**JEMY DESIGN CORP.
ARCHITECT OF RECORD JOSUE CRUZ
JAVIER R. MARIN, DESIGNER AIA**

FILE NUMBER: 23-DP-52

SUBJECT: Preliminary Site Plan review for mixed-use development including 44 residential units and approximately 1,500 square feet of commercial space (Parkside Vue)

DIAGRAM
F.A.R. CALCULATIONS

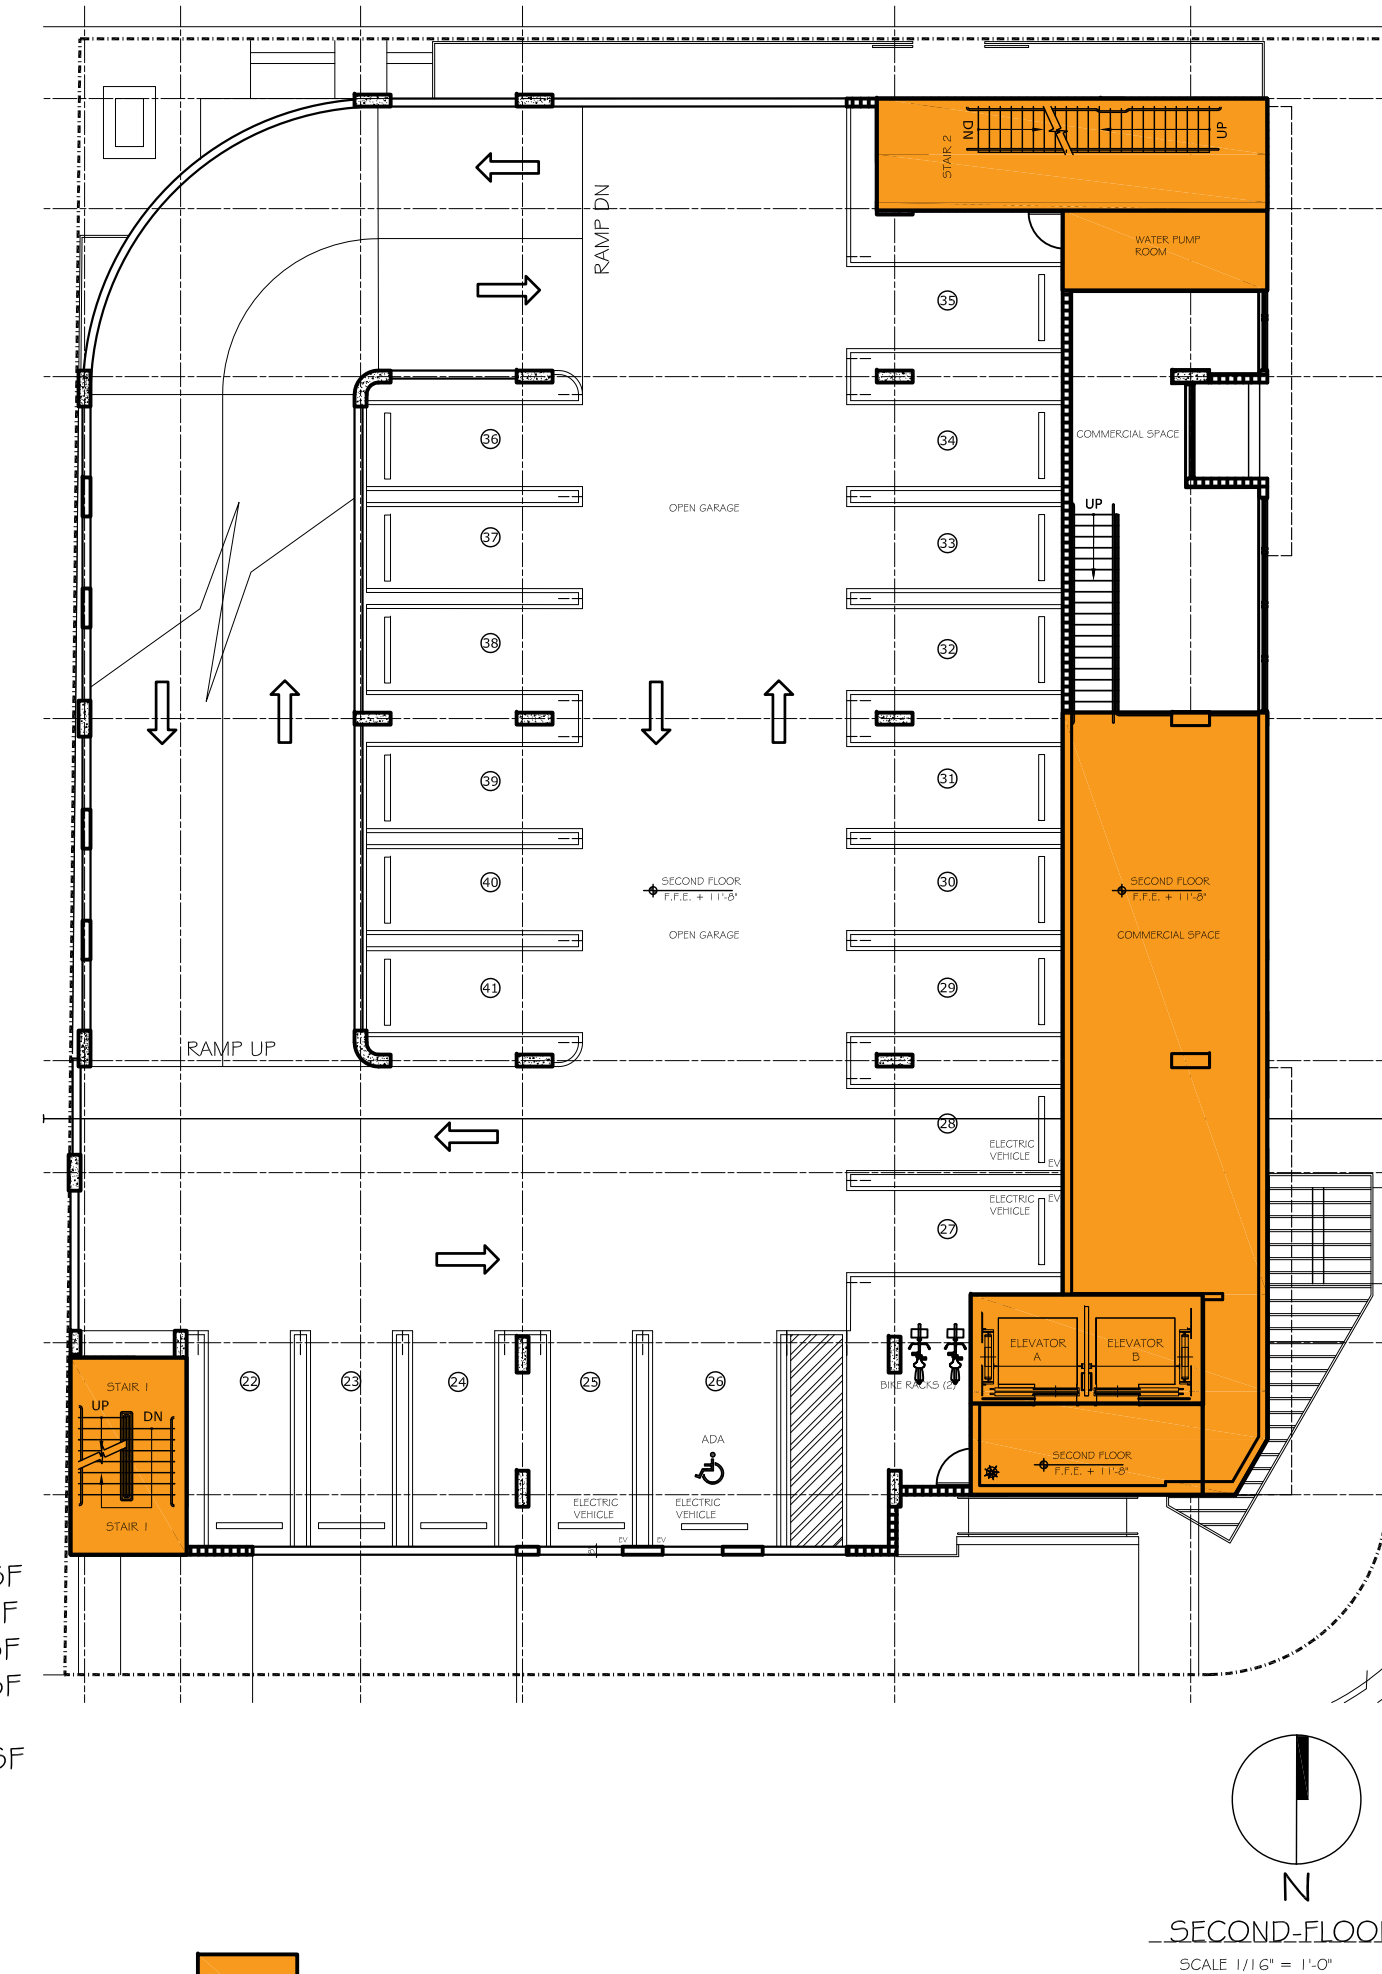
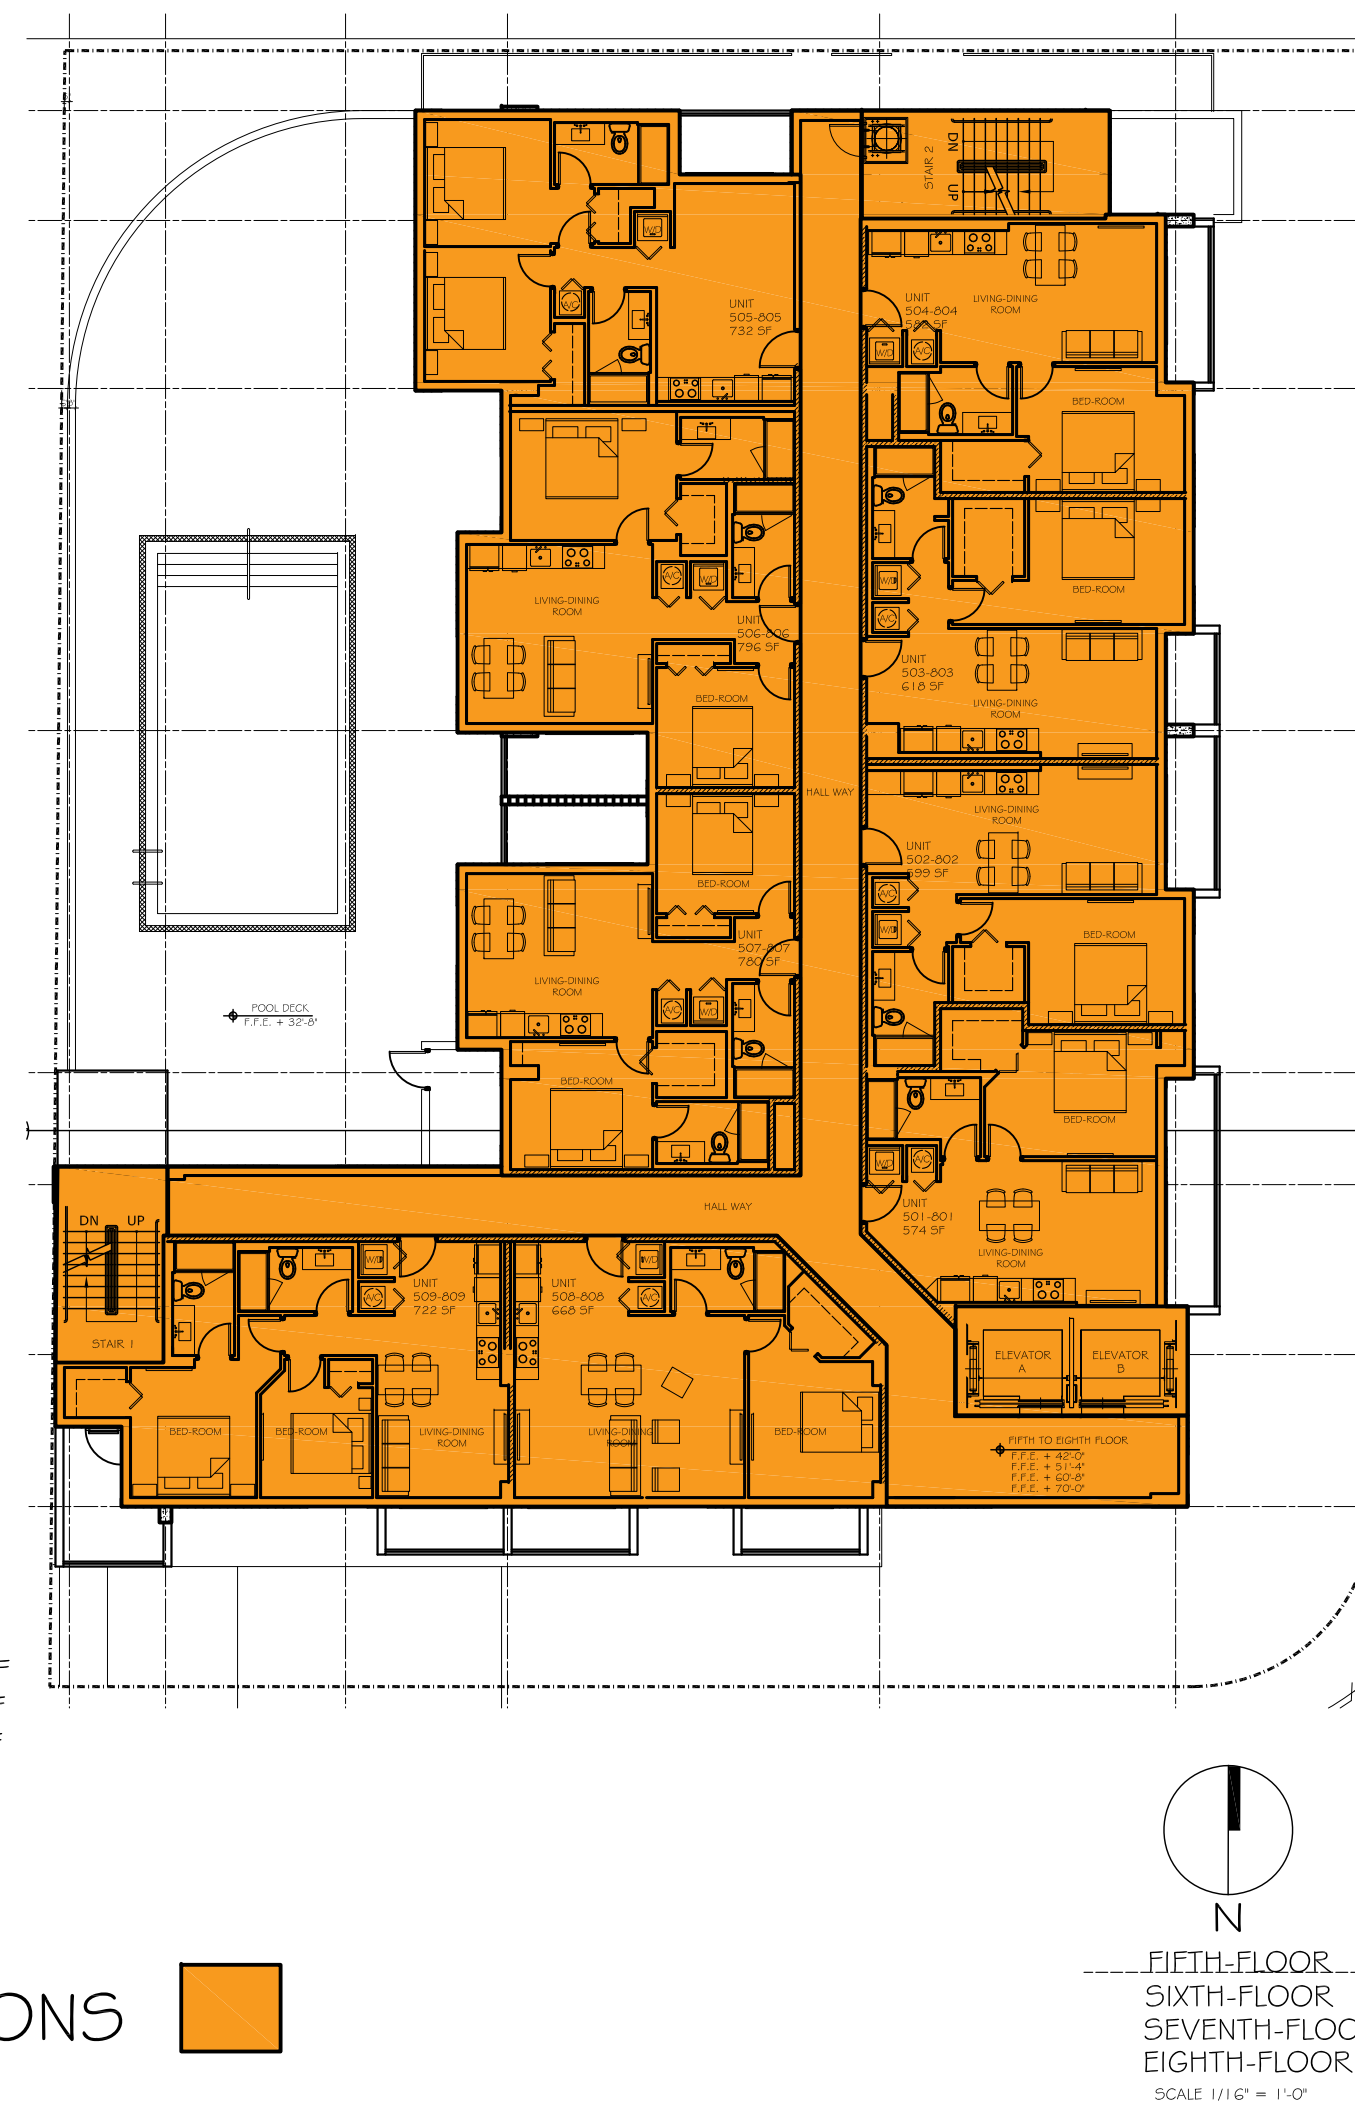
3. Show a diagram how the FAR has been calculated. Please provide on a separate sheet. **PROVIDED A-002**
4. Work with the City's Landscape Architect to ensure that all landscape requirements are met. **UNDERSTOOD**

SHEET TITLE: GROUND FLOOR, SECOND FLOOR		
PROJECT NO: 202205		
Drawings: NCP		
DATE: 6-02-2022	SCALE: NOTE	
SHEET: A-C005

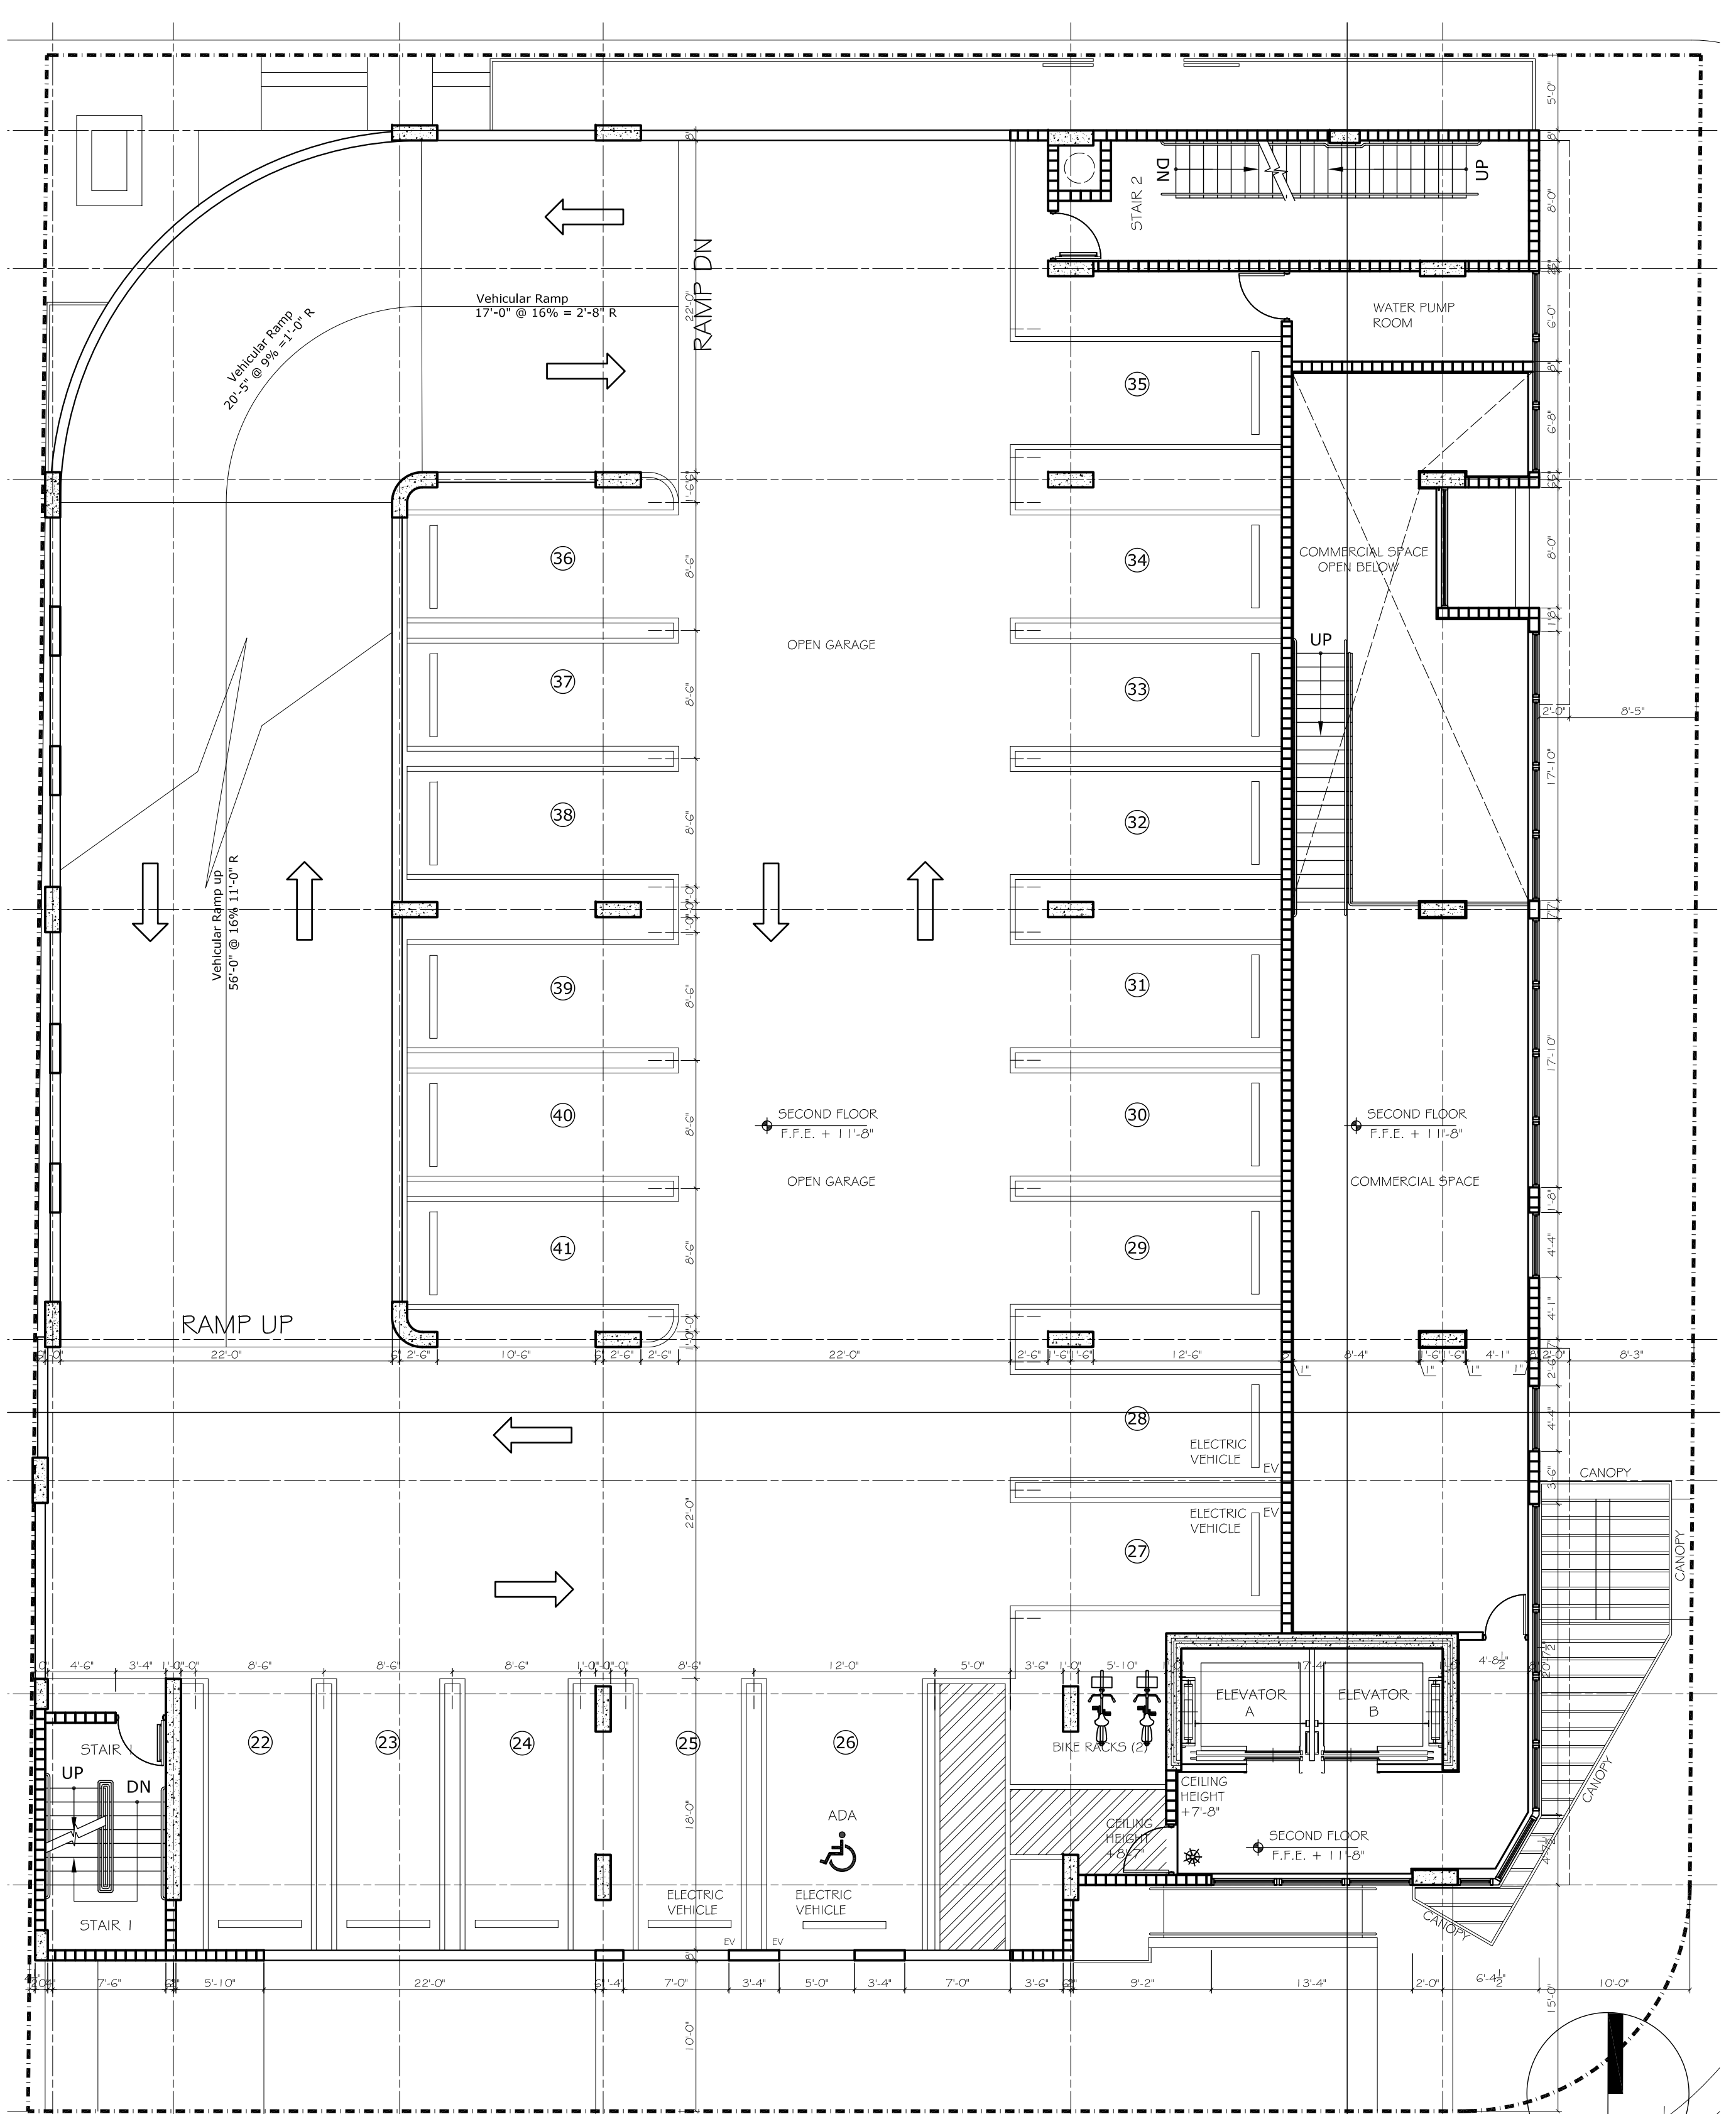
1. Indicate on the site plan where the infrastructure necessary for future installation of electric vehicle-charging equipment will be located. (See 151.154, Ordinance O-2016-02) Consider placing it adjacent to a handicapped space so that the future charger will be accessible from both types of spaces. Recommend to locate the charging stations on the visitor parking spaces. **PROVIDED A-001, A-005, A-006**

14. Parking stalls shall be numbered consecutively throughout the 3-floor parking garage. **PROVIDED A-001, A-005, A-006**
 15. Please fully dimension all parking stalls (depth for all stalls) and drive aisles on plans. Including the vehicle turn around stalls (standard parking stall requirements applied), pedestrian areas, and non-vehicular areas. **PROVIDED A-001, A-005, A-006**

17. Please identify the slope of all proposed car ramps to each level of the garage. **PROVIDED A-001, A-005**
 18. Please identify the ceiling height of the garage at the entrance and at each floor on the site plan. **PROVIDED A-001, A-005**
